AMENDED IN RED

PLANS AND DOCUMENTS referred to in the PDA DEVELOPMENT APPROVAL

Approval no: DEV2024/1510
Date: 12 June 2024

CLIENT: Gonzalez-Munoz Pty Ltd off Gonzalez Munoz Disc Trust
AT: LOT 8444, CARNAVON CRESCENT
BANYA, QLD 4551

SITE PLAN
1:200

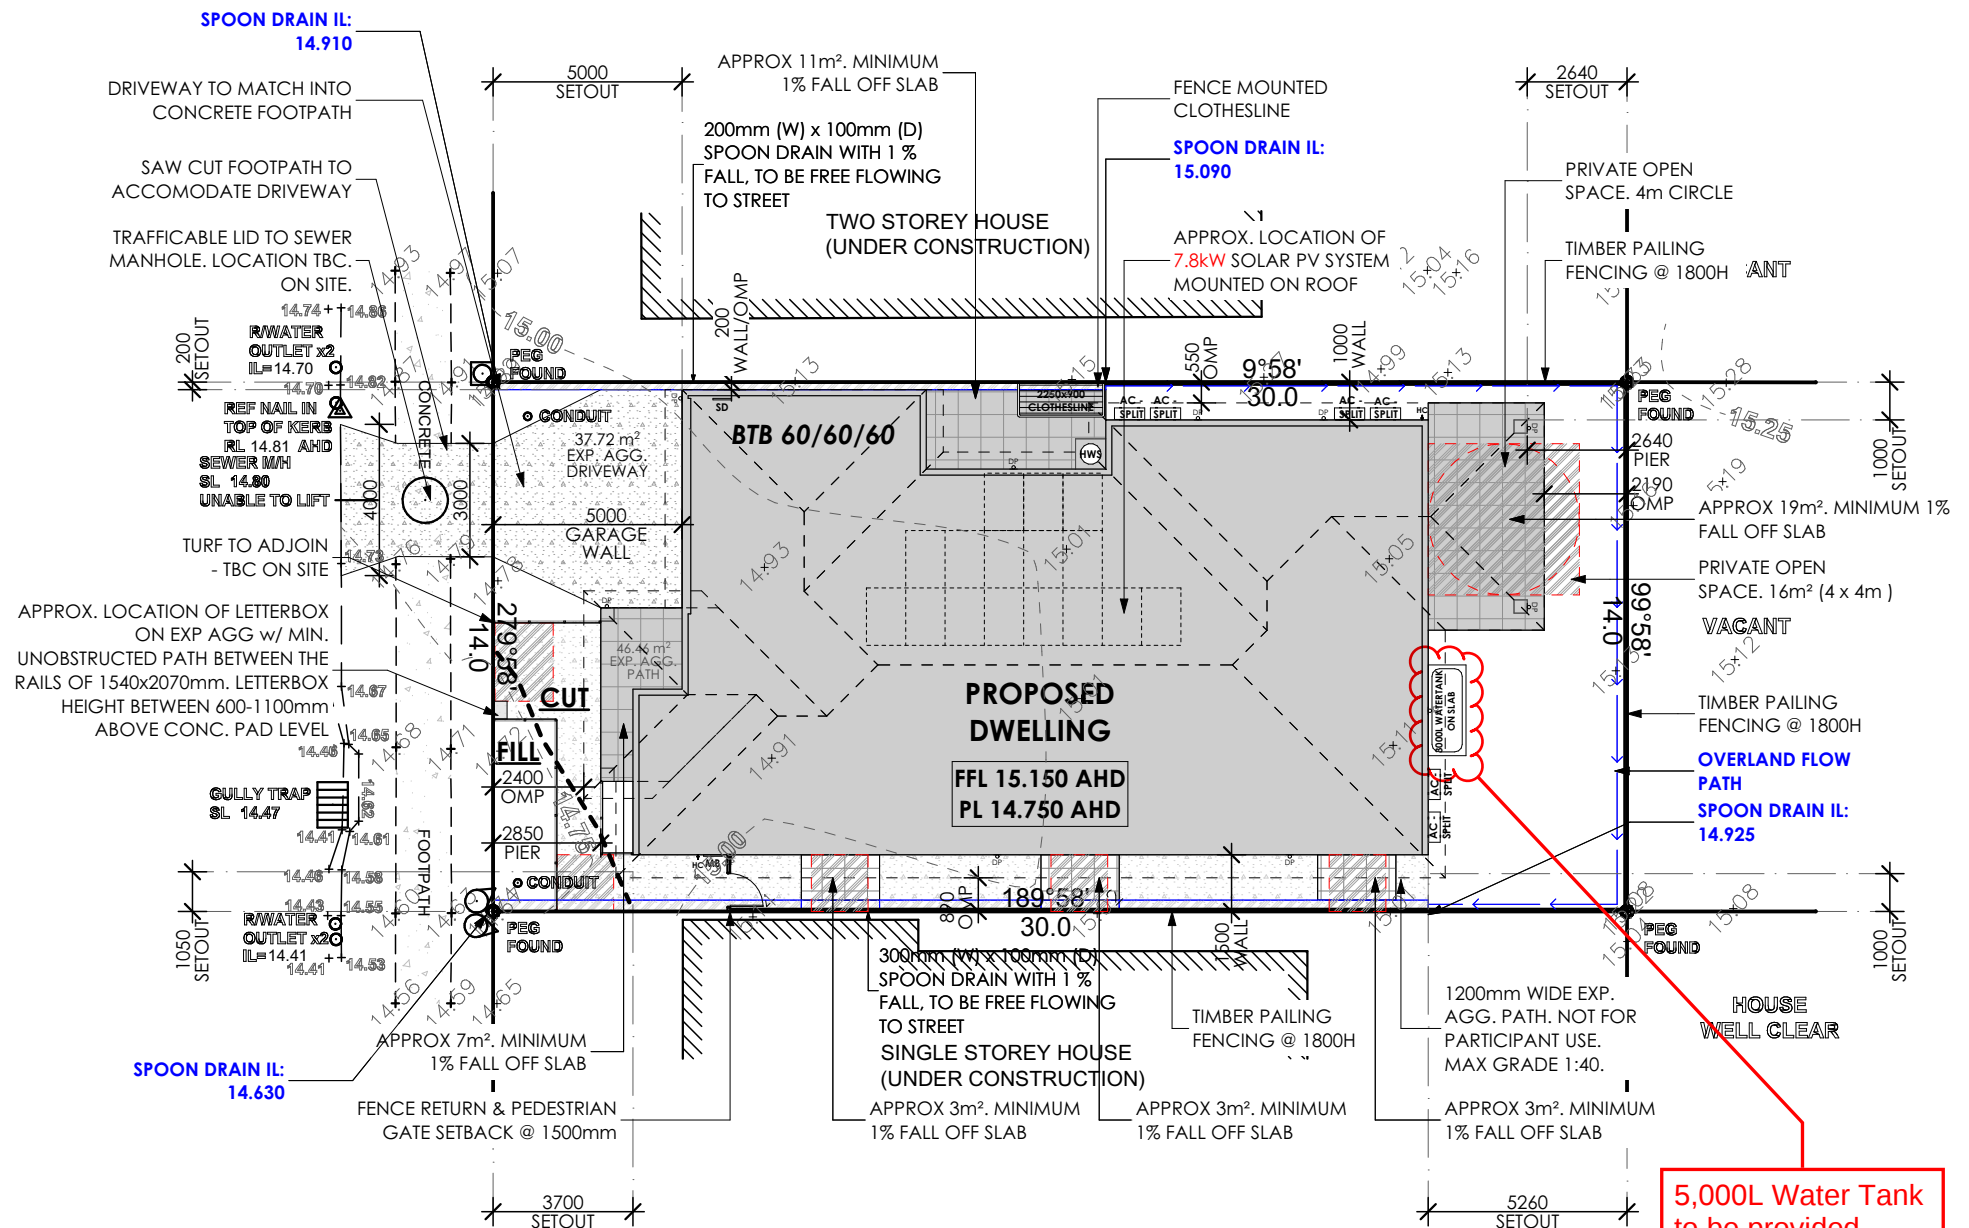
NOTE: - PATH TO FRONT BOUNDARY TO BE DETERMINED ON SITE.

Title: ELEVATIONS
Page: 10

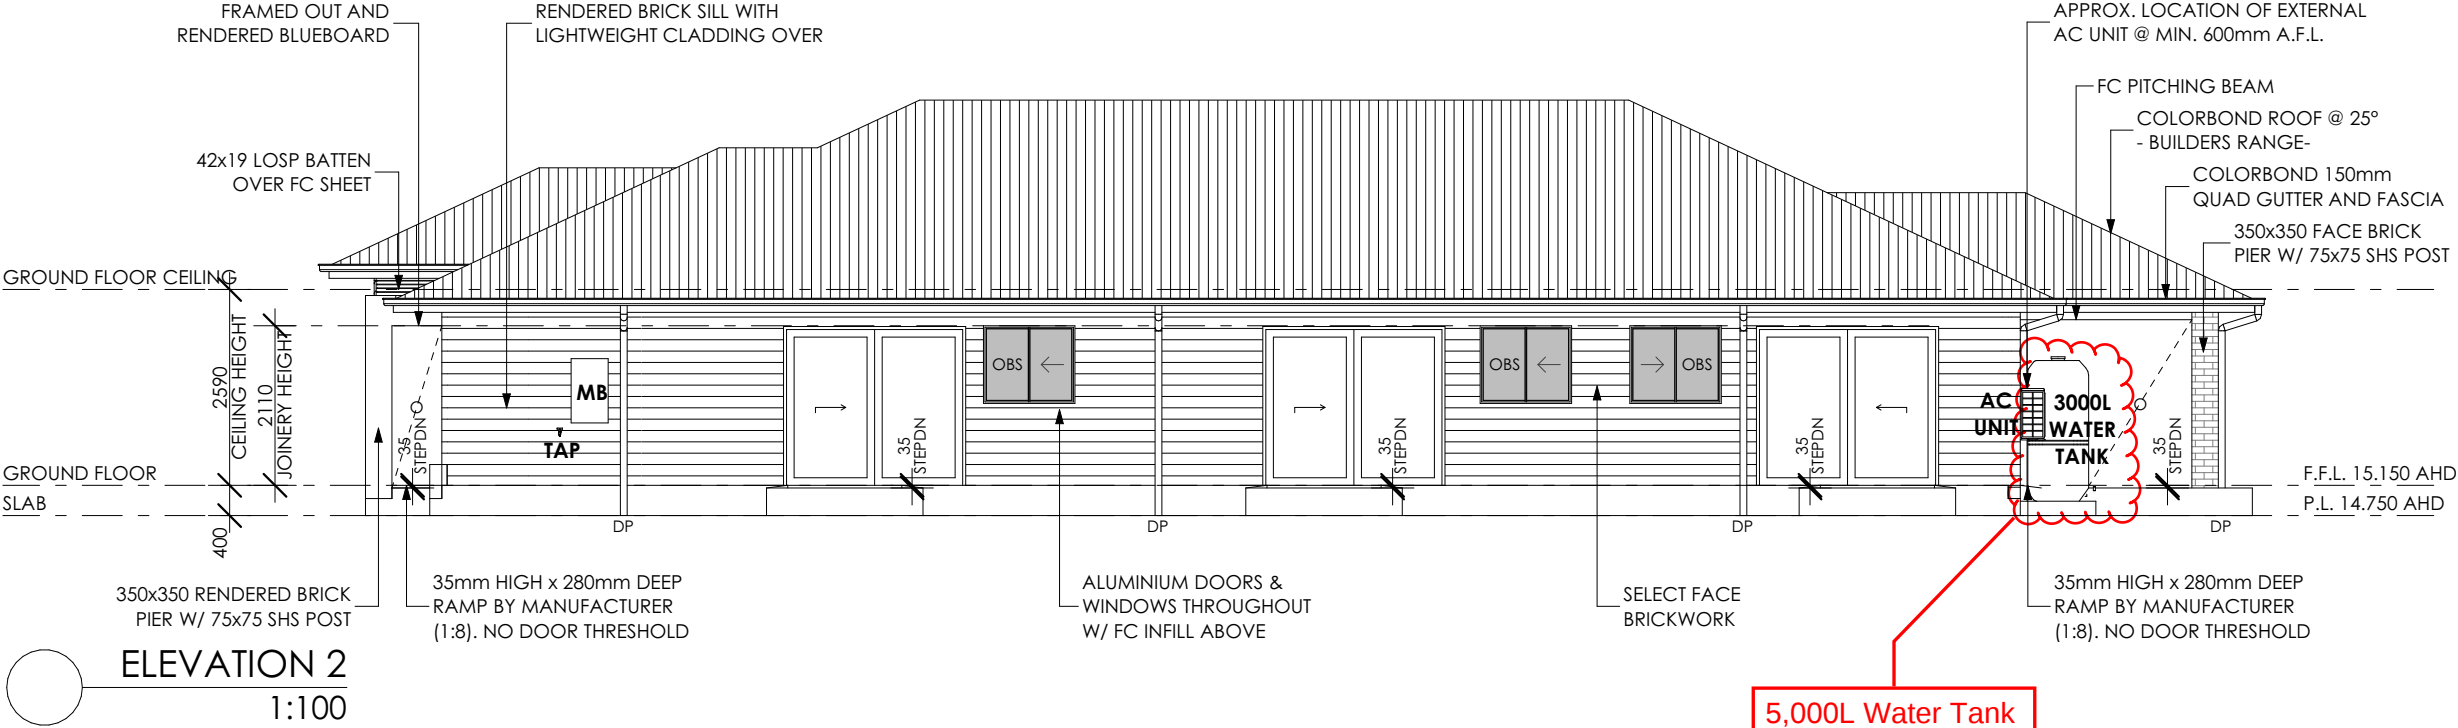
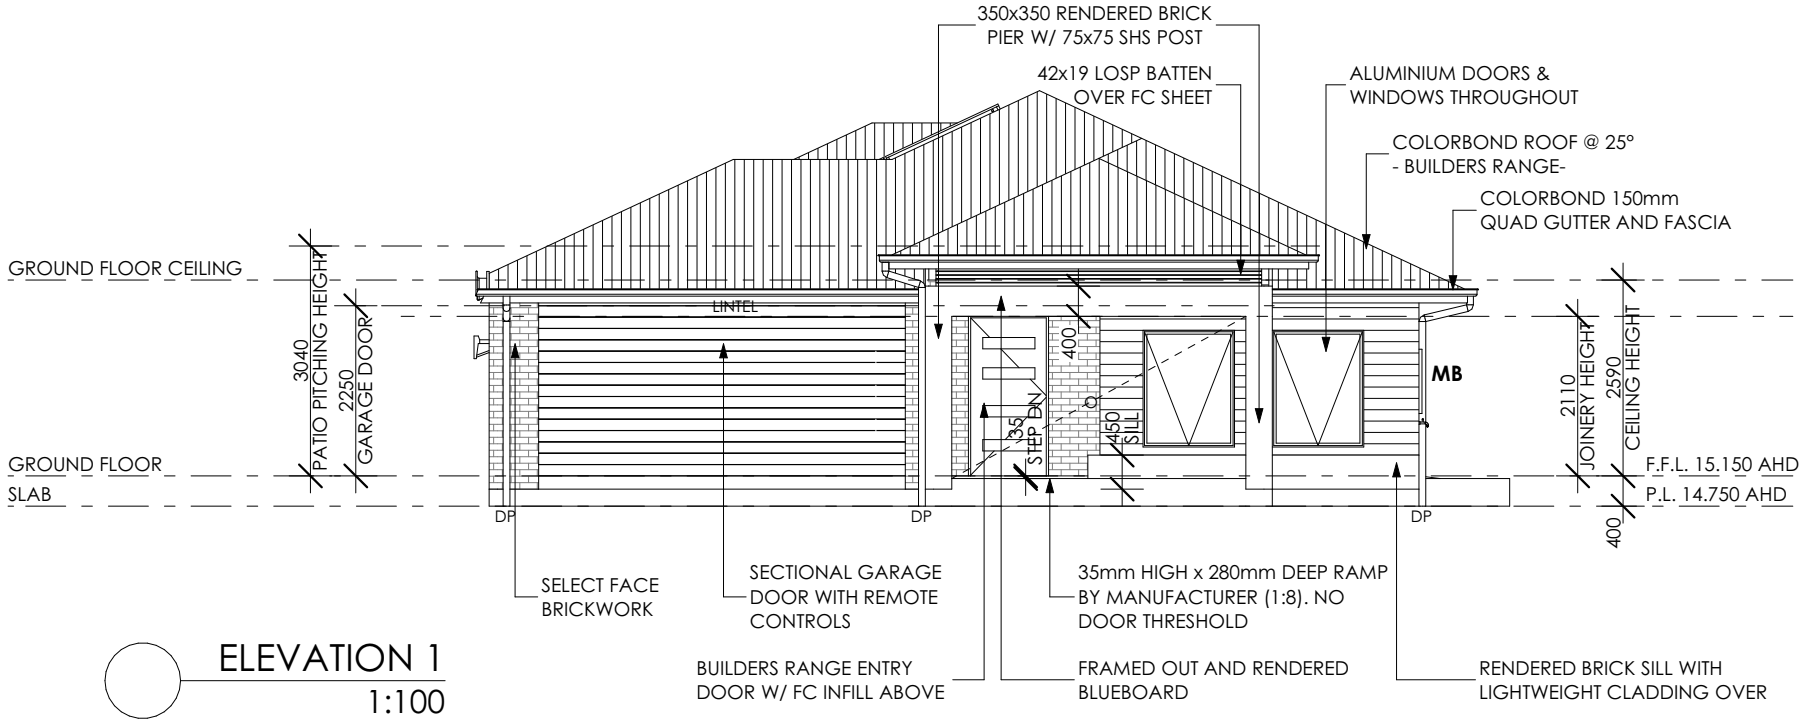
5,000L Water Tank
to be provided

AMENDED IN RED
